**CITY OF BATON ROUGE
PARISH OF EAST BATON ROUGE
DEPARTMENT OF ENVIRONMENTAL SERVICES**

ADDENDUM NO. 3

SUBJECT: **SULLIVAN ROAD SEWER SANITARY SEWER IMPROVEMENTS PROJECT
CITY-PARISH PROJECT NO. H.002320**

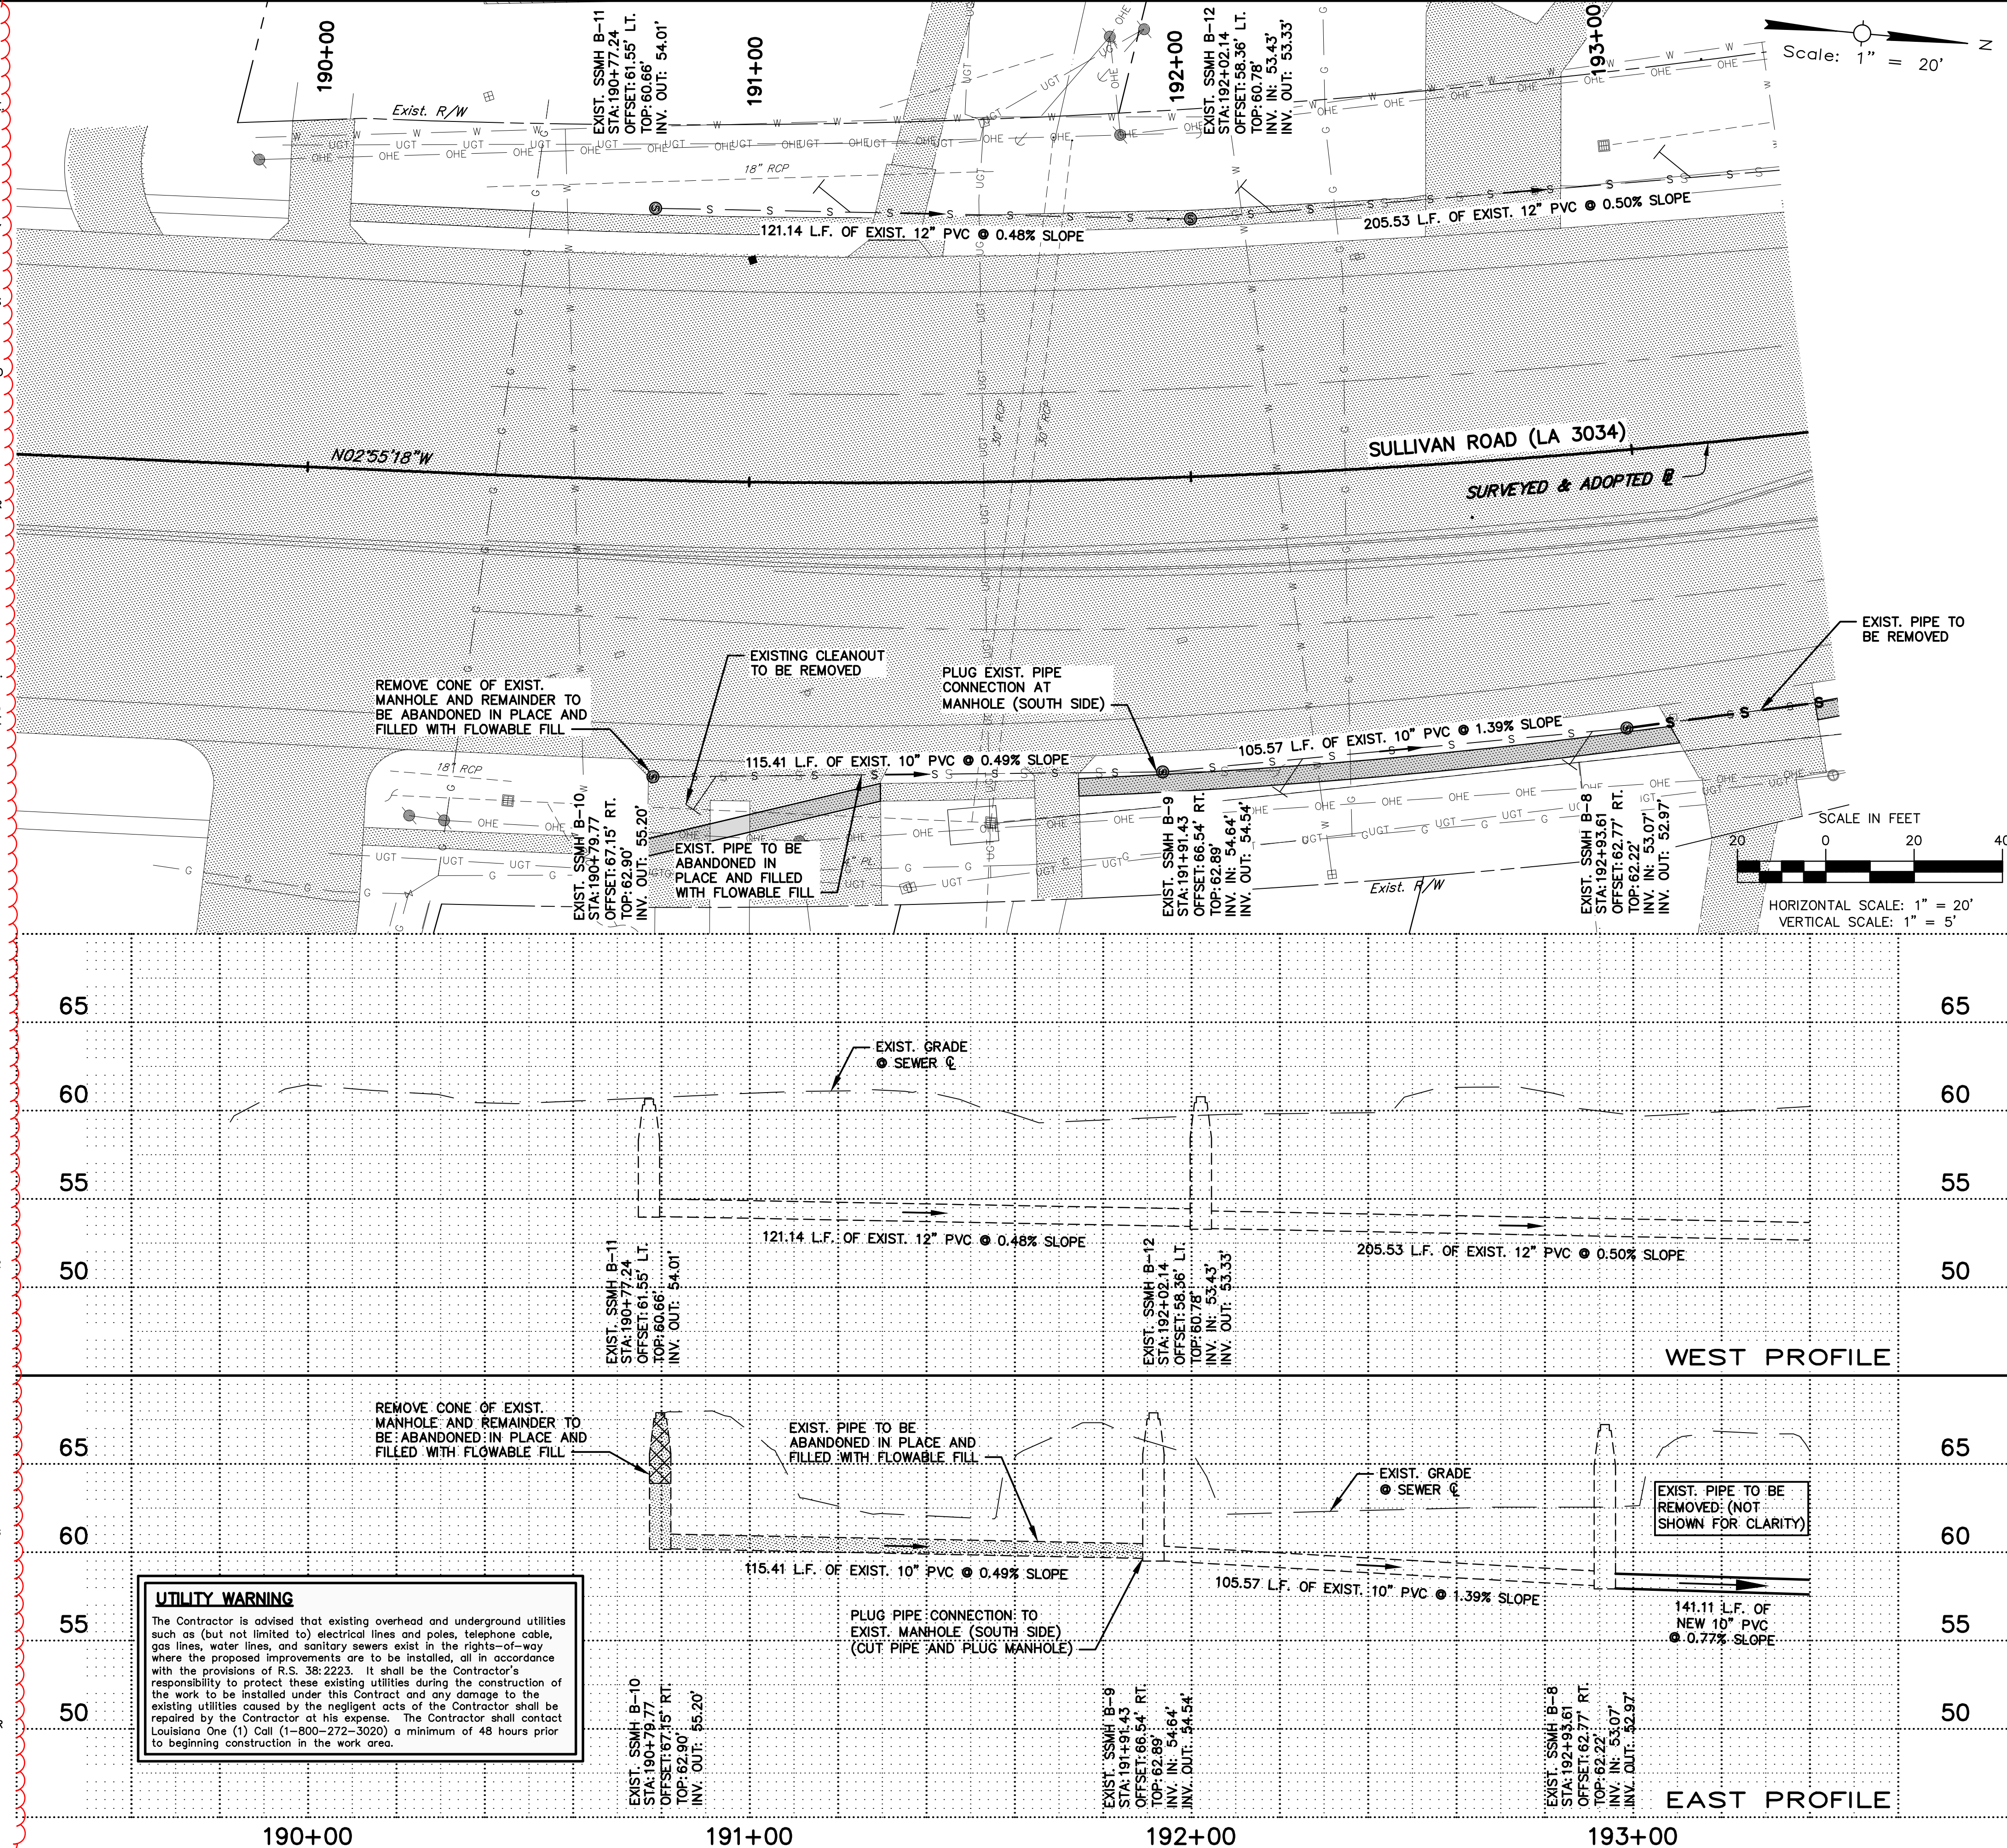
1. Replace Sheet 57 with the attached 57R.
2. Add EBR Standard Plan 902-06 to the drawings.

13. Plan Sheet 57 Note 15 states that contractor should monitor and avoid settlement of adjacent structures listing the Ochsner Building and 11248 Sullivan Road. The geotechnical report Part 3.1.1 states "At a minimum the Ochsner Building should be included in pre-construction survey and construction monitoring as concerns have already been raised regarding excavation adjacent to structures. Exactly which other structures to be surveyed should be determined in consultation with all parties involved." What type of monitoring of existing structures will be required?

18. Plan Sheet 57 Note 7 requires contractor to coordinate the bracing of existing poles adjacent to excavation. Who will pay the cost associated with bracing poles? If contractor is required to pay, please add bid item to cover this unknow cost?

19. Plan Sheet 57 Note 13 requires contractor to adjust new and reused manholes flush with final grade. Are the manholes to be reused shown at the elevation they are currently set at? If not, can you please provide us with the current elevation of all existing manholes to be reused?

20. Plan Sheet 57 Note 18 requires contractor to test and repair existing manholes and service stacks that are to be reused. There is no way for the contractor to know the condition of these manholes and stakes. Would you please add a bid item for patching existing manholes, leak injecting existing manholes and replacement of service stacks?

56. On sheet 57, General Note 1 states that sewer lines crossing water lines shall have "adequate structural support". Please define what is being required.

58. On sheet 57, General Note 15 says the Contractor is to monitor adjacent structures. Are there any requirements of how these structures are to be monitored?

See Note 14 on revised Sheet 57R.

The Contractor will be responsible for the pre-construction survey of existing structures (Ochsner building and 11248 Sullivan). See Note 14 on revised Sheet 57R.

The Contractor shall not be responsible for the condition of existing manholes that are currently installed. Contractor shall verify the conditions of these manholes subsequent to performing the flowable fill installation. However any damages caused to the existing manholes during the construction will be the responsibility of the Contractor. See Revised Sheet 57R.

See Revised Sheet 57R.

9. WATER MAIN CROSSING WITH STEEL CASING AND SEWER PIPE SITS FOR ACTUAL LENGTH. THE OPEN CUT METHOD AND BACKFILLED WITH CLSM. CONTRACTOR SHALL PRODUCE A TRAFFIC CONTROL PLAN FOR APPROVAL BY LADOT. CASING PIPE SHALL BE BEDDED IN ACCORDANCE WITH THE SAME SIZE GRAVITY SEWER LINE (UNDER PAVEMENT) DETAILS. GRAVITY PIPES INSIDE CASING SHALL BE RESTRAINED JUNT (CERTALOCK OR EQUAL), CASING SPACERS SHALL ALSO BE INCLUDED IN THE PAY ITEM.

13. GRAVITY EXCAVATIONS IN THE SURFICIAL CLAY SOLS CAN GENERALLY BE KEPT DRY BY PUMPING FROM A SUMP. HOWEVER, EXCAVATIONS WHICH APPROACH THE UNDERLYING SAND SHALL BE PROTECTED AGAINST HYDROSTATIC PRESSURES WHICH CAN EXIST IN THE SAND. BEFORE SUCH EXCAVATIONS ARE MADE, THE WATER LEVEL IN THE SAND SHALL BE CHECKED WITH A STANDPIPE. TO INSURE AGAINST A "BLOWOUT" OF THE BOTTOM OF THE EXCAVATION, PRESSURE RELIEF SHALL BE PROVIDED IN THE SAND. THIS IS DONE BY PUMPING THE WATER FROM A VACUUM UNDERGROUND Dewatering SYSTEM. THE PLANNED SEWER EXCAVATIONS WILL REQUIRE Dewatering WITH WELLPOINTS. ANY EXCAVATIONS WHICH EXTEND INTO THE SAND SHOULD HAVE THE WATER LEVEL CHECKED BY A STANDPIPE BEFORE EXCAVATION TO CONFIRM THAT THE Dewatering SYSTEM IS KEEPING THE GROUND WATER BELOW THE BOTTOM OF EACH PLANNED EXCAVATION. THE WATER LEVEL AS MEASURED BY THE STANDPIPE MUST BE MAINTAINED A MINIMUM OF 2 FEET BELOW THE BOTTOM OF EXCAVATION AT ALL TIMES THIS SHALL BE DONE WITH A WELLPOINT Dewatering SYSTEM.

14. AS PROTECTIVE MEASURES FOR EXISTING STRUCTURES, THE CONTRACTOR ALSO SHALL ESTABLISH SURVEY MONITOR POINTS AND COMPLETE MONITORING OF SELECTED STRUCTURES OF CONCERN DURING CONSTRUCTION. THE PERFORMANCE CRITERIA SHALL BE THAT NO MOVEMENT OCCUR AT THE STRUCTURE. ANY DEVIATION FROM THE PERFORMANCE CRITERIA WILL STOP WORK UNTIL THE CONTRACTOR SUBMITS AND INSTALLS AN UPDATED DESIGN THAT MEETS THE PERFORMANCE CRITERIA.

TWO STRUCTURES ARE PARTICULARLY CLOSE TO THE PIPELINE THE OCHSNER BUILDING (APPROXIMATELY 27 FEET AWAY) AND 11248 SULLIVAN (HOUSE APPROXIMATELY 18 FEET AWAY).

CONTRACTOR SHALL CONDUCT A PRE-CONSTRUCTION SURVEY OF THESE TWO EXISTING STRUCTURES ADJACENT TO THE PROJECT LIMITS IN ACCORDANCE WITH LADOT STANDARD SPECIFICATION 804.11. (NOTE: THAT SECTION 804 REFERS TO "PILE DRIVING ACTIVITIES", HOWEVER THIS ALSO APPLIES FOR ALL CONSTRUCTION/PIPE LAYING ACTIVITIES IN THIS PROJECT). WHEN PLANNED EXCAVATIONS ARE ADJACENT TO IDENTIFIED STRUCTURES OF CONCERN THE CONTRACTOR SHALL DESIGN TEMPORARY BRACING, SHIELDING, AND PROTECTIVE MEASURES TO PREVENT SETTLEMENT OF THE ENGINEER'S DESIGN. SHALL BE SEEN BY THE CONTRACTOR'S TEAM AND METHODS IN THAT AREA.
